DEVIATION REQUEST AND DECISION FORM

Project Name :	Crossroads Mixed-Use Preliminary Plan
Schedule No.(s) :	5408007005
Legal Description :	A portion of Tract B 24/94 Business Park Fil No. 1, as amended by affidavit of correction rec. #219097386

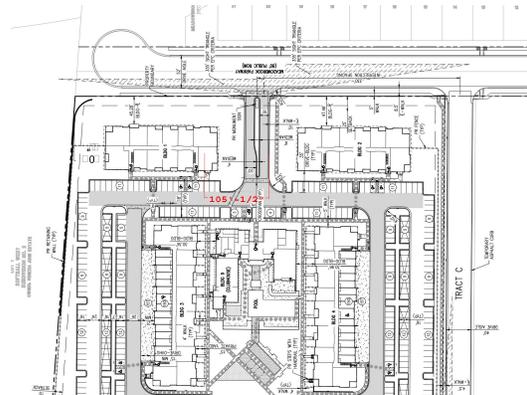
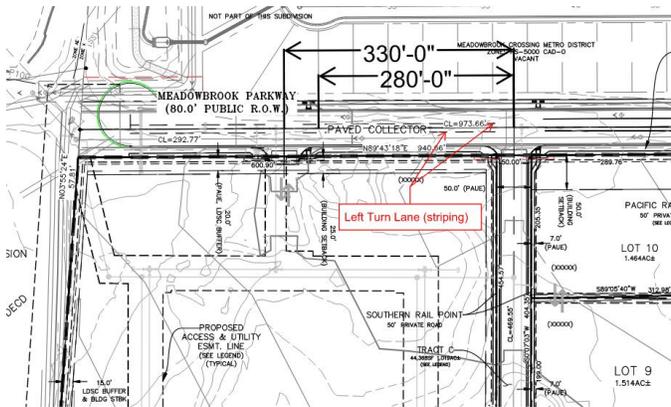
330-foot spacing exists between the "West" access (multifamily driveway) on Meadowbrook and the "Middle" access (Southern Rail Point). According to the TIS, there is approximately 260 feet of available space for a westbound left turn lane at the west access due to the proposed location of the middle access.

Since there are geometric constraints with reconfiguring buildings on site, supporting traffic analysis has been provided that includes justifications for why the westbound left turn lane at the west access from Meadowbrook parkway can be accommodated in the current location. An image of the preliminary plan and development plan call out are provided below for reference. (Images are not to scale)

Alternative Turn Lane Design to provide 50-feet of storage length (standard), and 50-feet (per deviation) of deceleration lane length (substandard), and a 160-foot taper (standard) within the westbound left turn lane at the "west access" along Meadowbrook Parkway to accommodate spacing restrictions. The taper (160') and storage (50') meet criteria, the decel lane (50') is required to be 155-feet; can be accommodated.

The design plan sketch has been updated to be larger and now provides a total length of 260 feet instead of the previous 280 feet while updating the individual length components.
